Product change information (PCN)

PCN No.:	AAB160104	Date:	11.04.2018
Product:	According to the product list

Distance ring modified

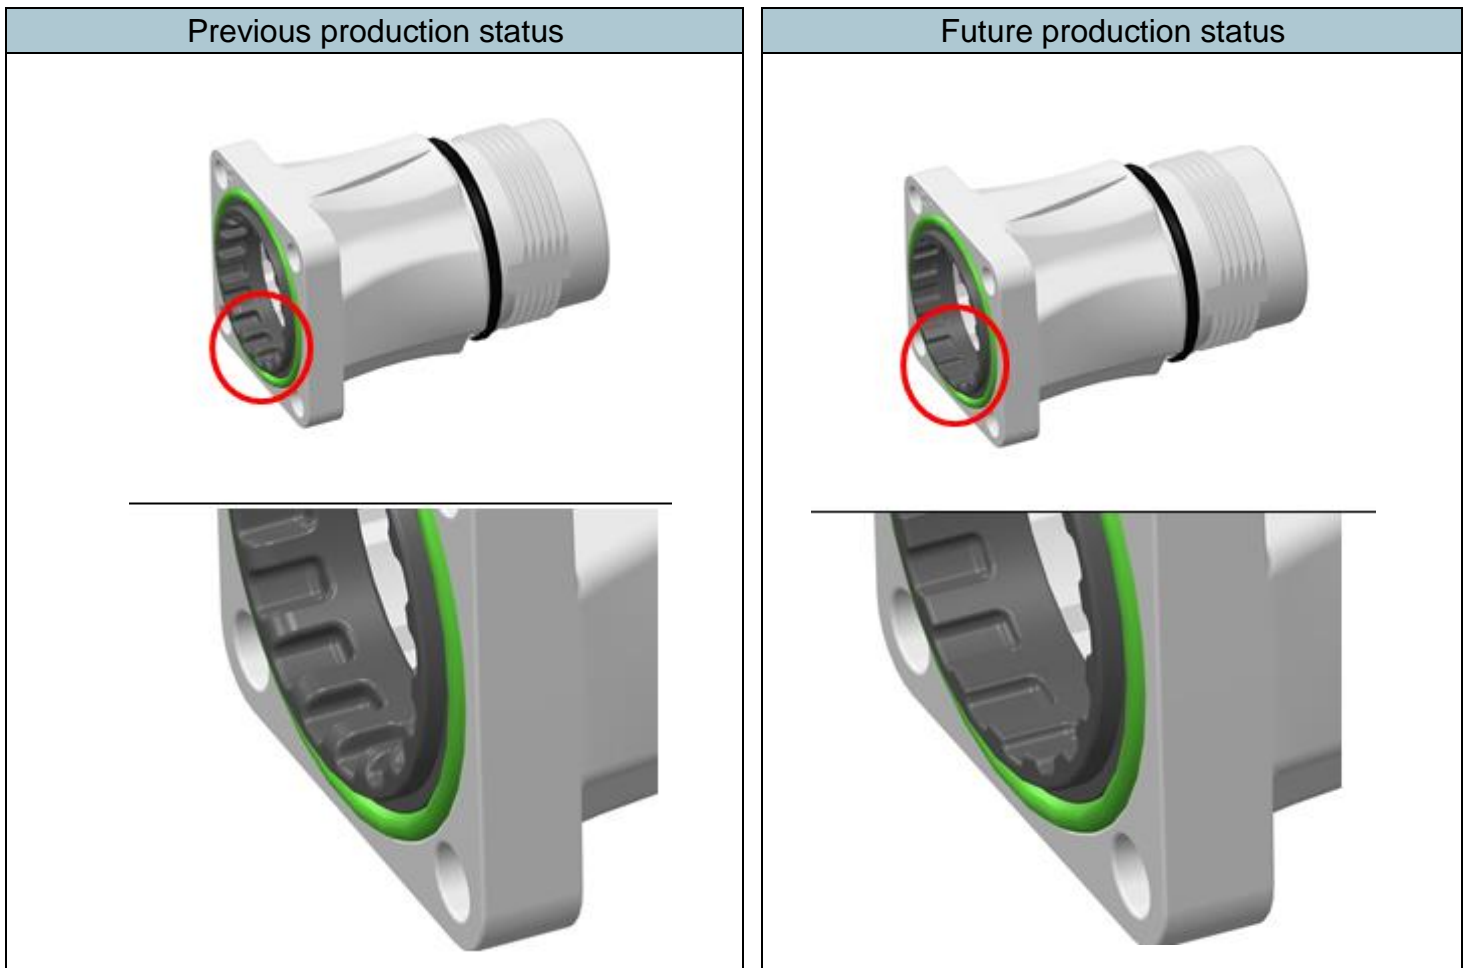
As part of the ongoing product improvement process, the shape of the distance ring is being modified. This simplifies mounting for larger litz cross sections and therefore increases process safety. This modification has no effect on tightness and the electrical properties of the connector.
